Access Compliance Report

Public Rights-of-Way

Intersection ID: 9632	Main Street: BOXFORD_CT	Cross Street: FLOWERS_CT	Location: SE
ADA ID: CFF810DAE3F9	Ramp Type: Perp	Initial Pass/Fail: Fail	Overall Compliance: No
Severity Score: 21.25			
Codes/Mitigation Info/Possible Solution		Field Measurements/Component Compliance

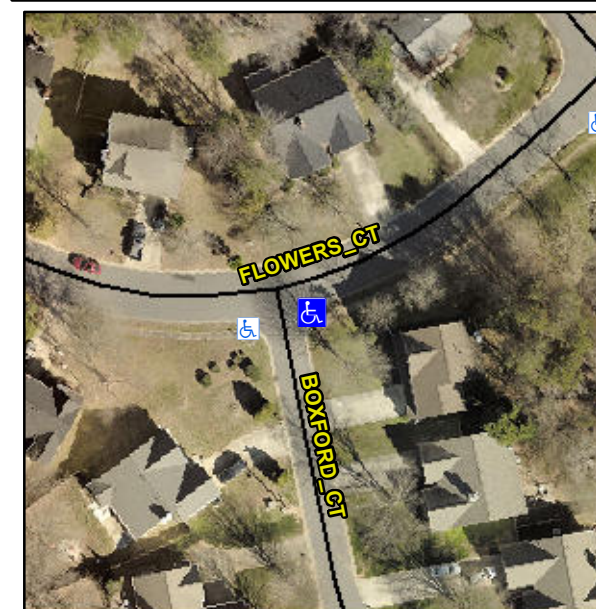
Not Found, R304.5.1, R304.2.2

Compliance	Description	Data	Compliance	Description	Data
N/A	Ramp Length (in)	95.5	No	Ramp Slope (%)	8.5
No	Ramp Width (in)	43.5	Yes	Ramp XSlope (%)	0.8
N/A	Flare Type LT	N/A	N/A	Flare Type RT	N/A
N/A	Flare Slope LT (%)	N/A	N/A	Flare Slope RT (%)	N/A
N/A	Flare Traversable LT?	N/A	N/A	Flare Traversable RT?	N/A
N/A	Landing Length (in)	N/A	N/A	DWS Provided?	N/A
N/A	Landing Width (in)	N/A	N/A	DWS Contrast?	N/A
N/A	Landing Slope (%)	N/A	N/A	DWS Length (in)	N/A
N/A	Landing X Slope (%)	N/A	N/A	DWS Full Width?	N/A
N/A	Landing Curb? (Y/N)	N/A	N/A	DWS Offset (in)	N/A
N/A	Shared Landing?	N/A			
N/A	Gutter Ponding?	N/A	N/A	Gutter Slope (%)	N/A
N/A	Gutter Lip Ht (in)	0.5	N/A	Gutter X Slope (%)	N/A
N/A	Painted X Walk1?	No	N/A	Painted X Walk2?	N/A
	X Walk 1 Direction	To W		X Walk 2 Direction	N/A
N/A	X Walk 1 Width (in)	N/A	N/A	X Walk 2 Width (in)	N/A
	X Walk 1 Slope (%)	1.6		X Walk 2 Slope (%)	N/A
	X Walk 1 X Slope (%)	1.7		X Walk 2 X Slope (%)	N/A

Remove & Replace Entire Ramp.
